520 WEST GEORGIA STREET (COMPLETE APPLICATION)
DE415285 - ZONE CD-1 (Pending)

EXECUTIVE SUMMARY

- **Proposal:** To develop this site with a 22-storey mixed-use building (commercial and office uses) over four levels of underground parking having vehicular access from Richards Street.

DEVELOPMENT PERMIT STAFF COMMITTEE RECOMMENDATION: APPROVE

A2.01

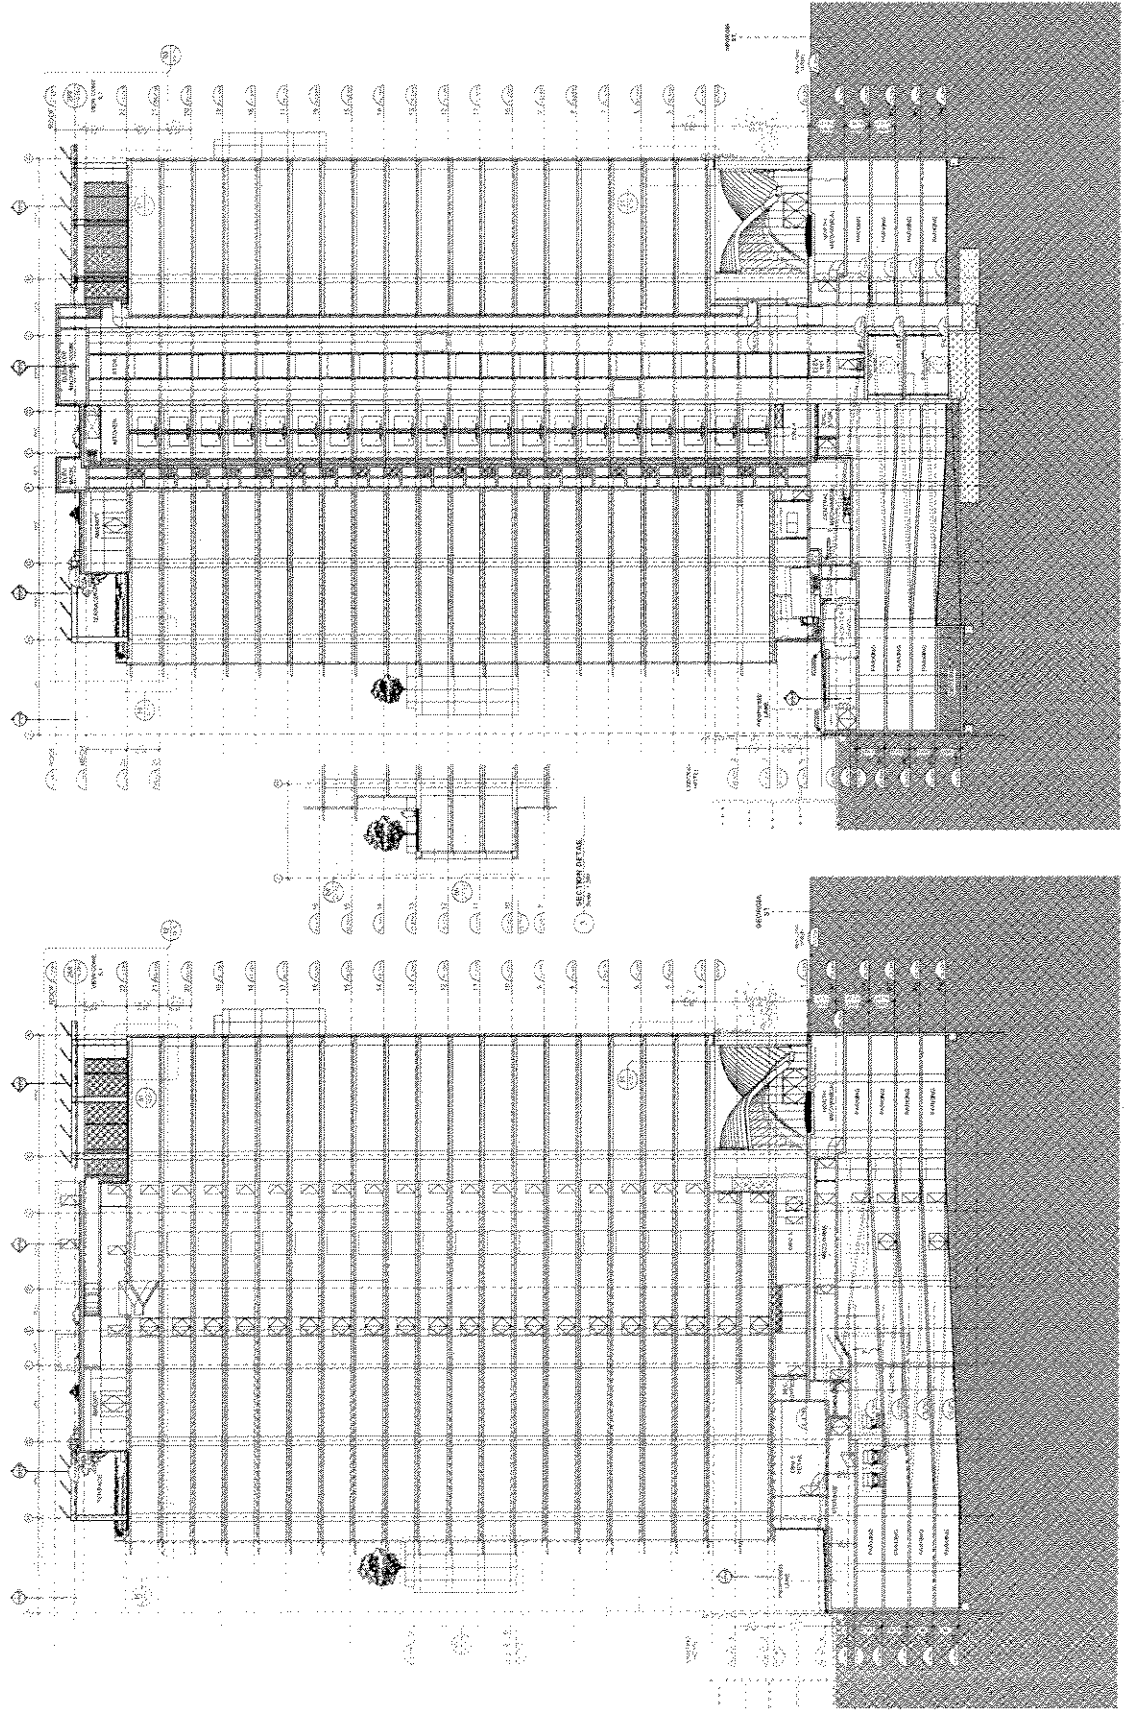
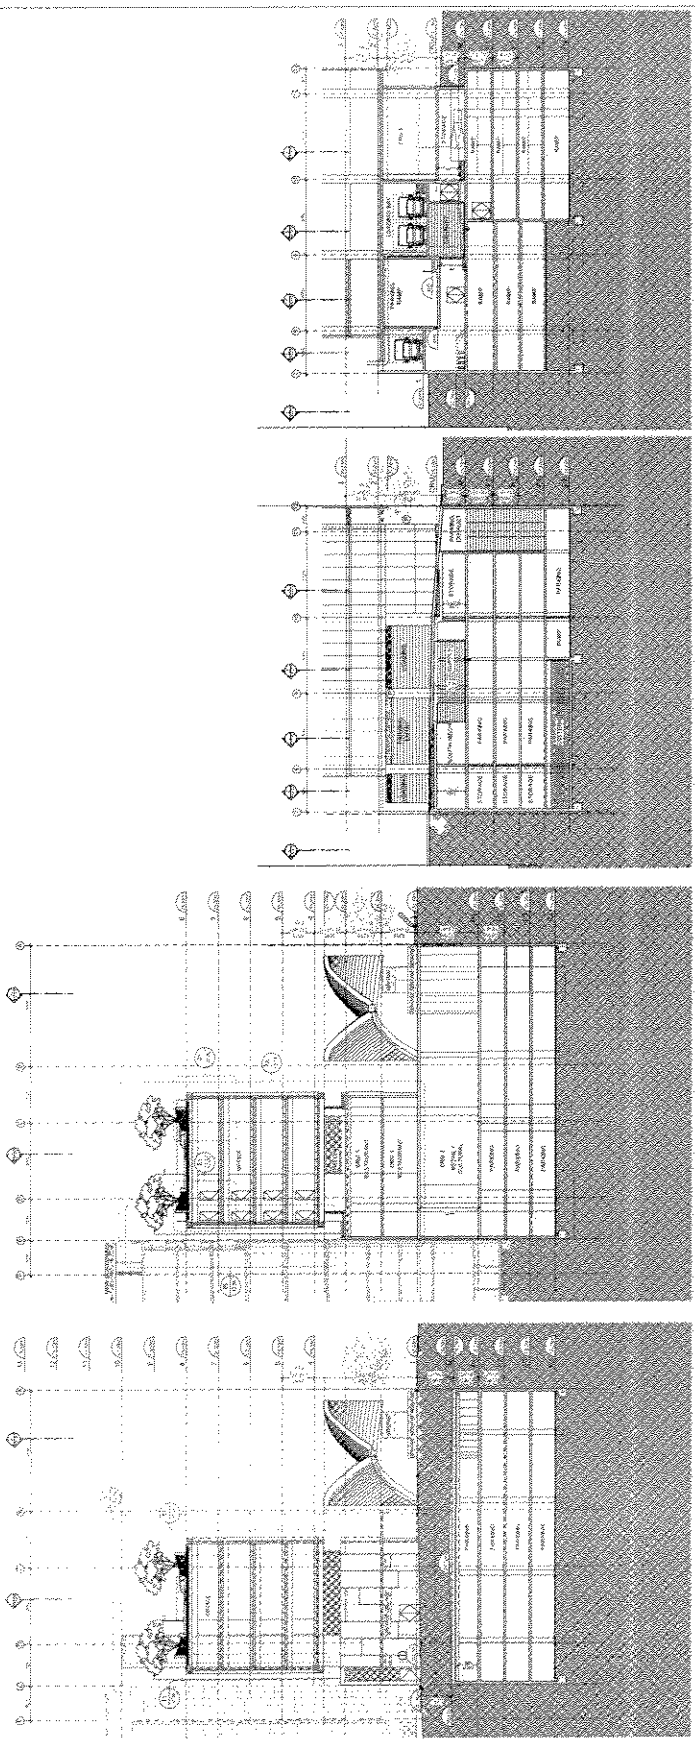
Note to Applicant: Sheets A2.01 and A2.02 show that not all of the lane outlet will have a full 7.62 m (25 ft.) of clearance. Some areas are impacted by the building overhang and will only have approximately 5.33 m (17.5 ft.) of clearance.

Plaza/Lobby/Pavilion—Previous Design

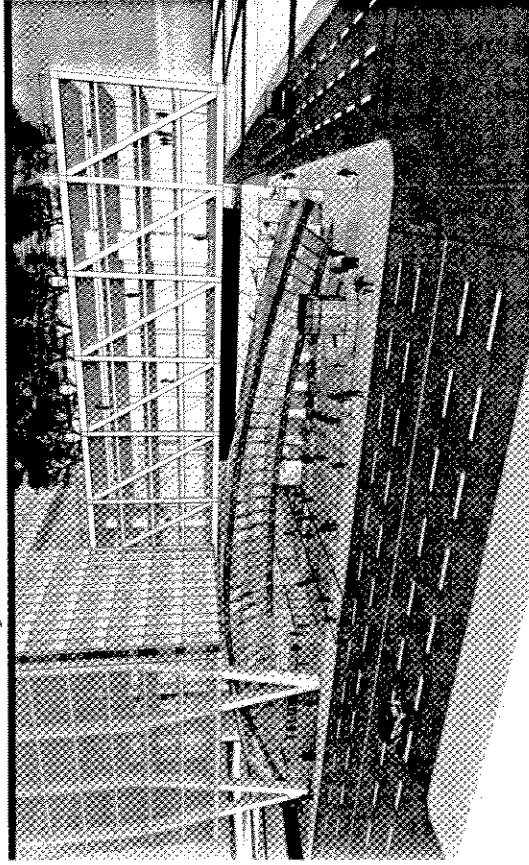
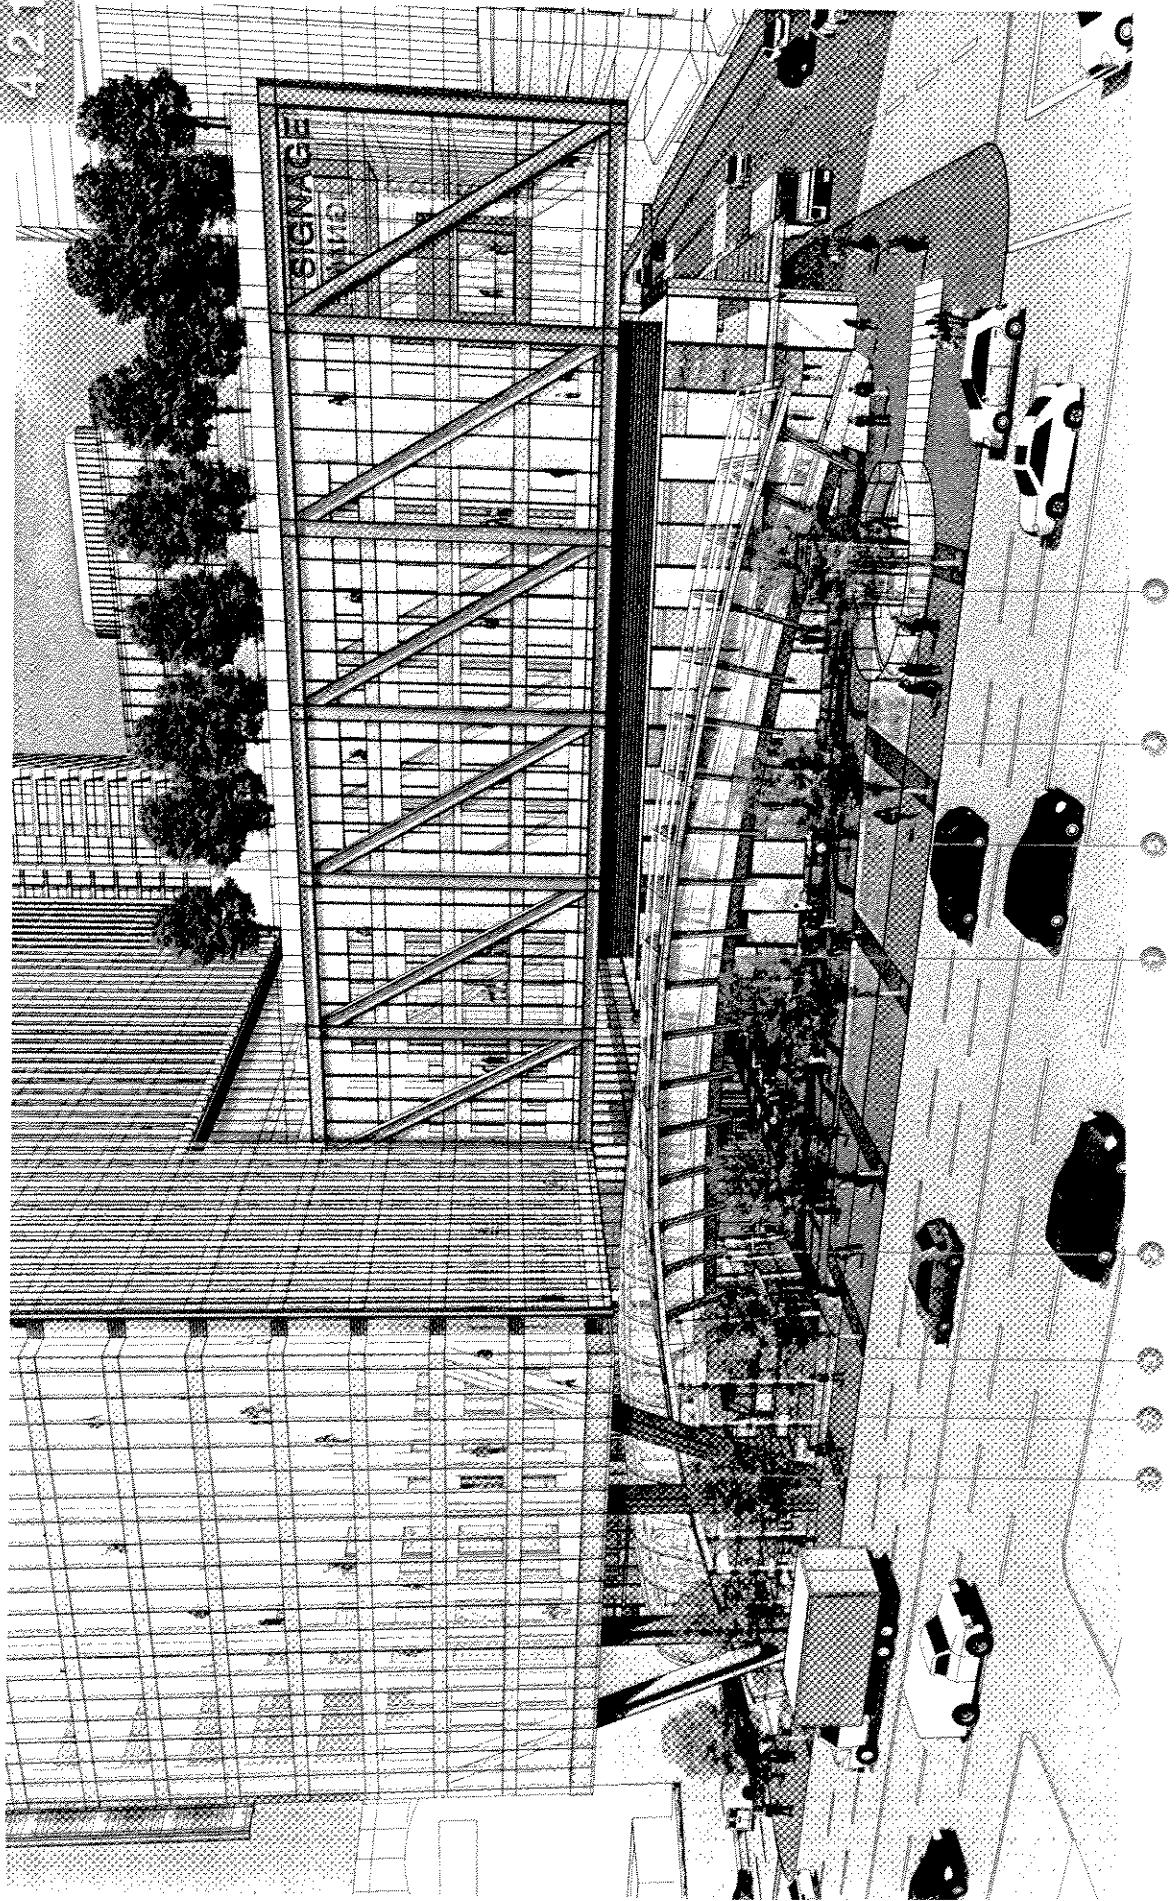
Applicant's Response: The Plaza has been refined to engage and enhance the pedestrian experience through the visual and physical connectively of public and private spaces, exterior and interior space.

The thin strips of basalt Plaza paving in a herringbone pattern extend seamlessly into the lobby, onto the sidewalk, and down the lane in one unified ground plane. The division of the indoors and outdoors is furthered blurred by the frameless structural glazing that forms the Lobby enclosure, and the arcing wood pavilion that transform from Plaza canopy to Lobby roof. Solar access in the pLaza is optimized by the abundant use of glass.

Retail Podium—Previous Design

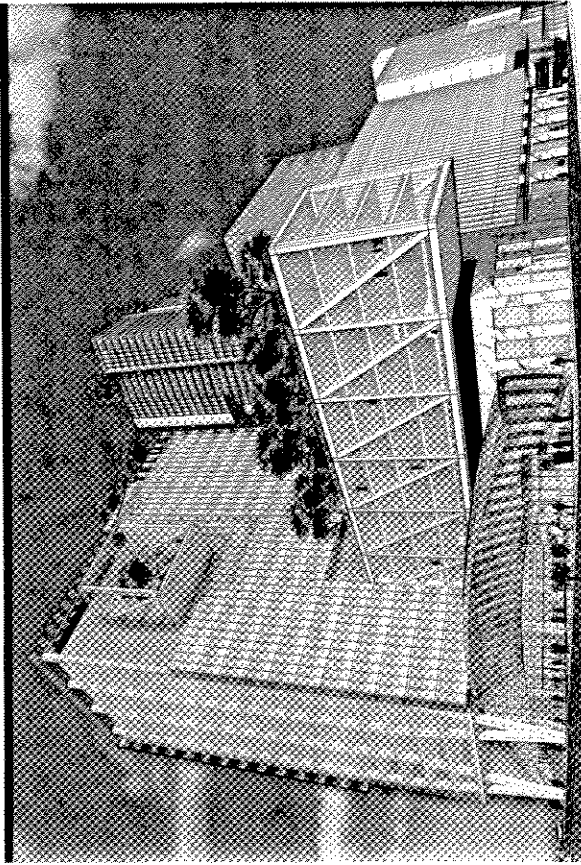
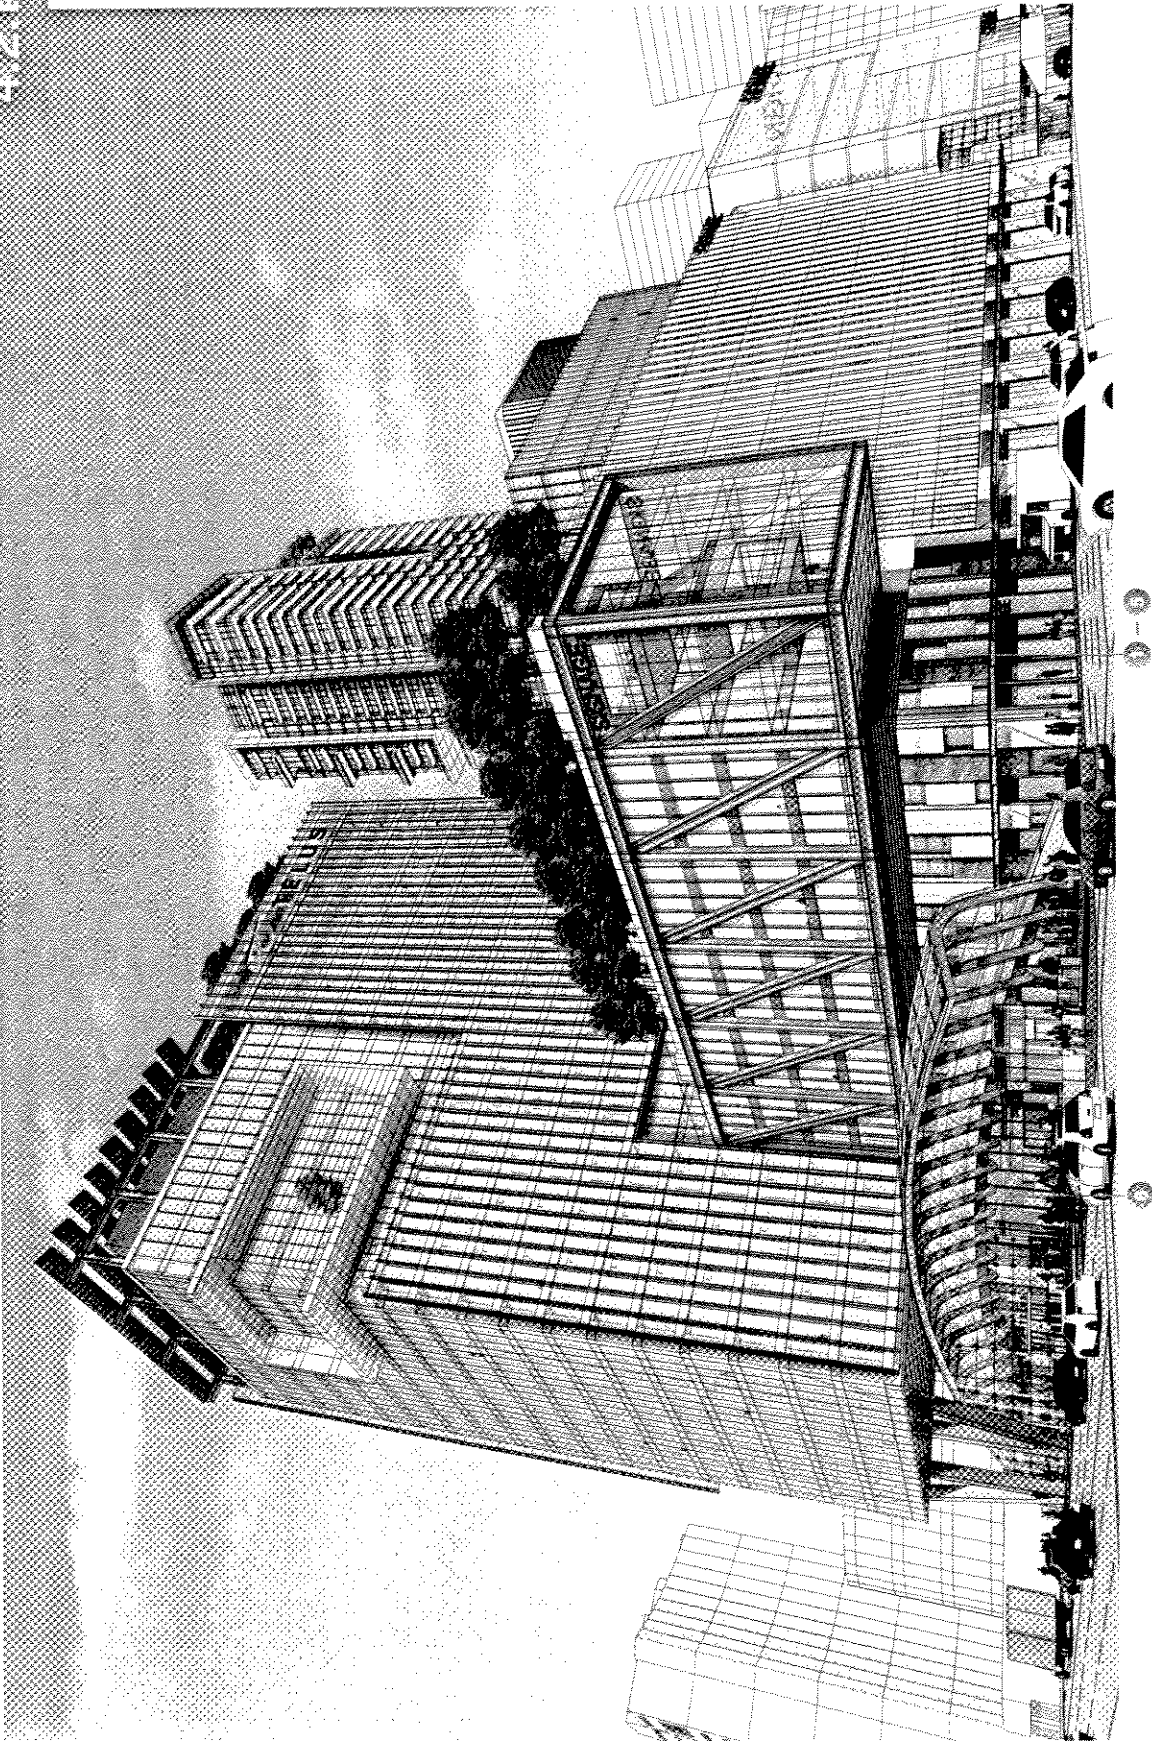
Applicant's Response: The Retail Podiums for both the Office and Residential Towers have a similar treatment of glass, aluminum fins and onyx panels. The randomly placed onyx panels provide pedestrian interest and variety. The system transfers seamlessly into weather protection, and formally responds to various tenancies to aid in wayfinding.
